York Street Interchange

Vector Re Routing
Proposal
Assessment

October 2015

Drawing Number
DRAWING 5
 Rev

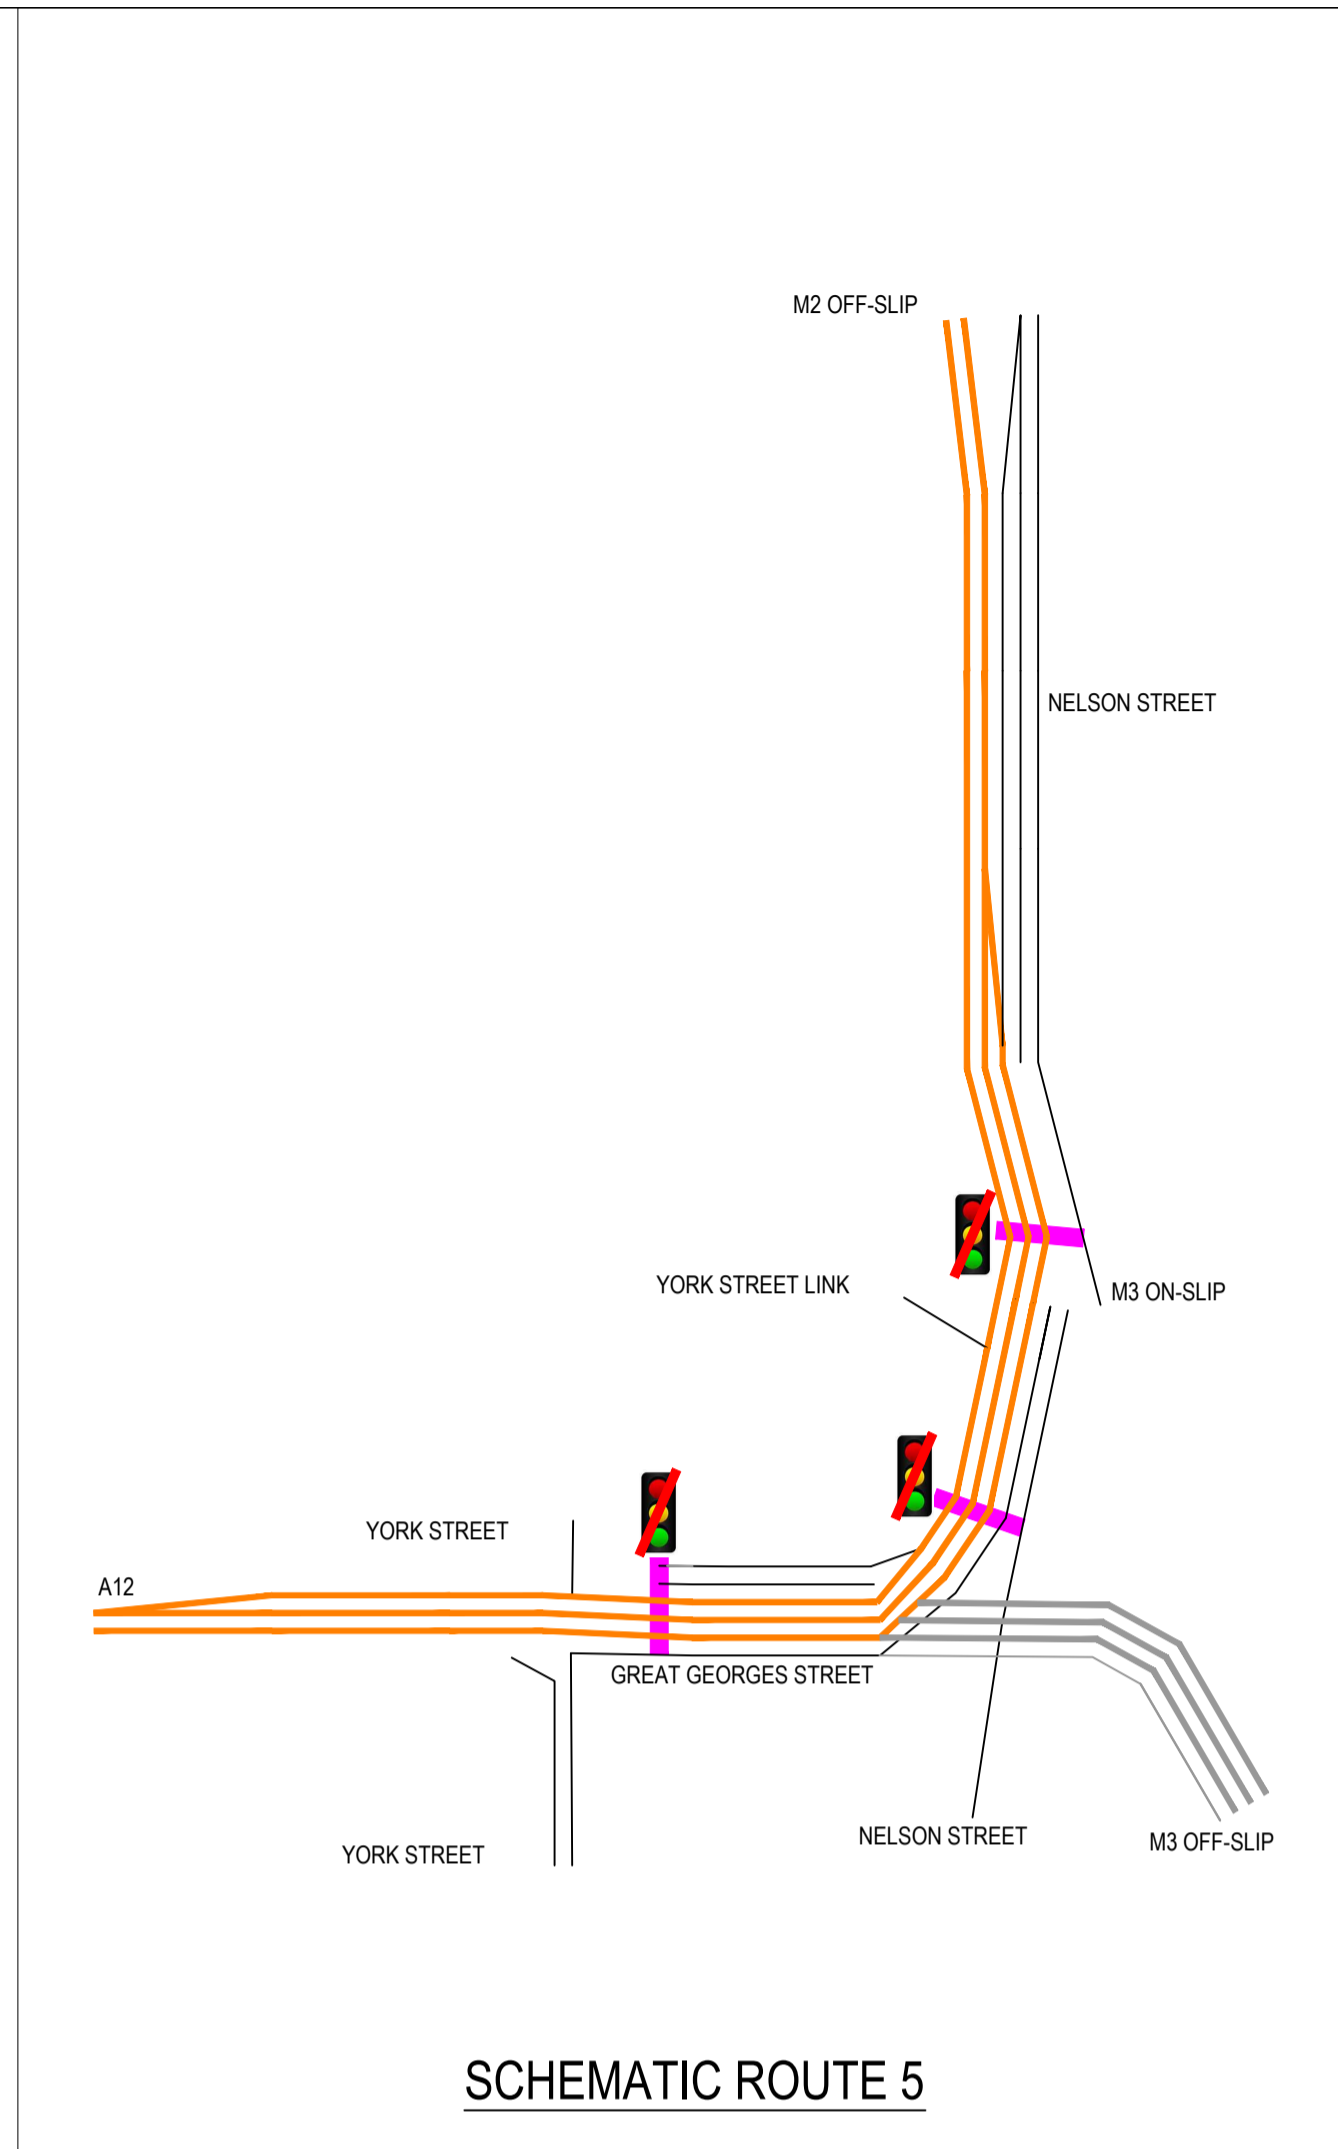
Drawing 6 in in Appendix A illustrates the Vector Proposal, along with a schematic diagram illustrating existing lane provision on the original and diversion routes.

The Vector Proposal does not provide sufficient details of lane configurations on Nelson Street and Great Georges Street. Based on the downstream capacity of the Westlink adjacent to York Street, only a maximum of three lanes can join the Westlink from Great Georges Street, reducing to two lanes at North Queen Street bridge. With the adjacent Route 6 providing a free-flow connection from the M3 to Westlink, it follows that only two lanes can be provided from Route 5, with lane two on the M2 to Westlink movement lost on approach to North Queen Street bridge. This lane reduction on the larger flows joining the Westlink from the M2 would likely create operational issues due to the effects of merging traffic.

In a similar manner to Route 5, the Vector Proposal does not provide sufficient details of lane configurations on the off-slip and Great Georges Street. This is particularly relevant given the downstream capacity of the Westlink away from York Street. With the adjacent Route 5 providing a free-flow connection from the M2 to the Westlink, with two lanes anticipated, it follows that only one lane can be provided from Route 6.

It would therefore follow that on the existing off-slip from the M3, the lane configuration would require alteration to reduce the number of lanes, similar to the Proposed Scheme. The Vector Proposal does not clarify the configuration but it could be reasonably assumed that the revised lane configuration on the off-slip would reflect that of the Proposed Scheme, with two lanes and a nearside auxiliary lane diverge. Of the two lanes, lane two would become the free-flow link to the Westlink and lane one would be designated for onward travel to Great Georges Street. The auxiliary lane diverge would be used to maintain the connection for City Centre via Nelson Street.
